Accessibility Design Review Report

Project Title: LAHC - Seniors Housing
17-21 Kimberley St, Merrylands

Job Number: 21527

Report Version: 21527_ADR_DA_v1.3

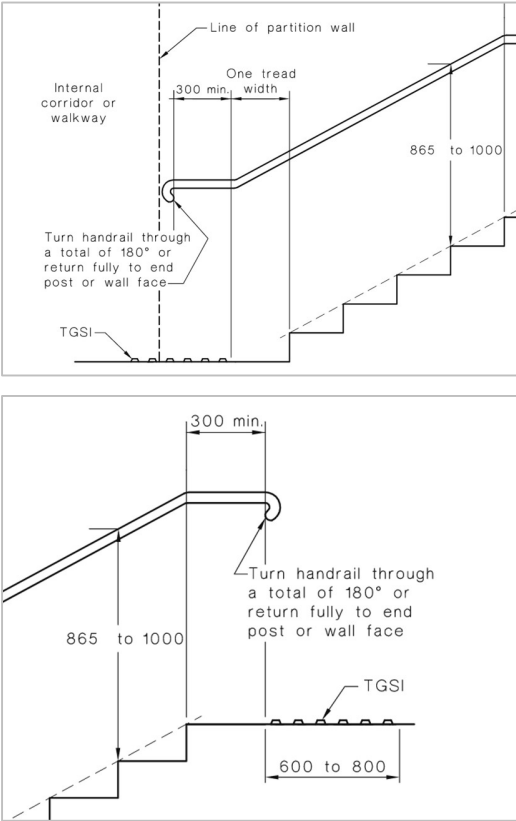
<p>external areas (<i>refer to example below or attached mark-up</i>).</p> <p>Ensure AS1428.1-2009 compliant access is achieved to storage areas & bin rooms provided for resident use.</p> <p><u>Paths of travel</u></p> <p>All pathways require a minimum unobstructed width of 1000mm. Pathways shall not include impediments such as steps or turnstiles without an accessible alternative provided.</p> <p>Circulation spaces prescribed by AS1428.1-2009 are required at changes in direction and other circumstances may require a greater width than 1000mm.</p> <p><u>Design Detail:</u></p> <p>Verification of slip resistant surface finishes on all accessways should be provided prior to OC sign off. It is recommended to refer to HB-198 for area ratings and test in accordance with AS4586-2013.</p> <p><u>Design Detail:</u></p> <p>Ensure any tracks/grooves (including for water shedding or sliding doors) and grate slots/holes are no greater than 13mm wide (depending on orientation) and are recessed to maintain flush/level pathways.</p> <p>7.5 Grates</p> <p><i>Grates shall comply with the following:</i></p> <p><i>(a) Circular openings shall be not greater than 13 mm in diameter.</i></p> <p><i>(b) Slotted openings shall be not greater than 13 mm wide and be oriented so that the long dimension is transverse to the dominant direction of travel.</i></p> <p><i>NOTE: Where slotted openings are less than 8 mm, the length of the slots may continue across the width of paths of travel.</i></p>
